SERVICE ADVISORY # 06-070

Breakaway Switch Replacement

Models Included:	2007 Outback & Springdale
Serial Number Range:	Outback: 4YDT21R237B450576 - 4YDT23K297B450667 Springdale: 4YDT2562075101336 - 4YDT2602375101541
Parts Required:	1 – Breakaway Switch KRV # 181655
Tools Required:	Phillips Screwdriver

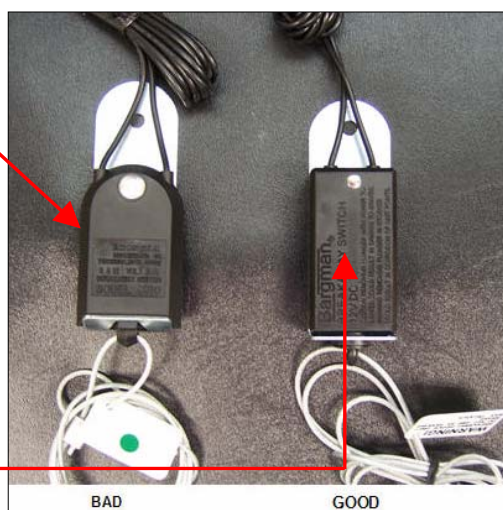
Keystone RV Company is conducting a voluntary **RECALL** notification campaign in accordance with the National Traffic and Motor Vehicle Safety Act. Some of the trailers listed were manufactured with a Tekonsha breakaway switch. The Tekonsha breakaway switch may not activate the trailer brakes in the event of the trailer separating from the tow vehicle. The following instructions correct the problem.

Step 1: Verify the breakaway switch is a Tekonsha brand switch. See figure 1.

BAD (Recall) ITEM:

- Curved (rounded) at one end.
- One screw placement.
- Tekonsha brand.

Step 1: Replace the Tekonsha breakaway switch with a Bargman breakaway switch.

GOOD (Replacement) ITEM:

- Square at both ends.
- One screw placement.
- Bargman brand.
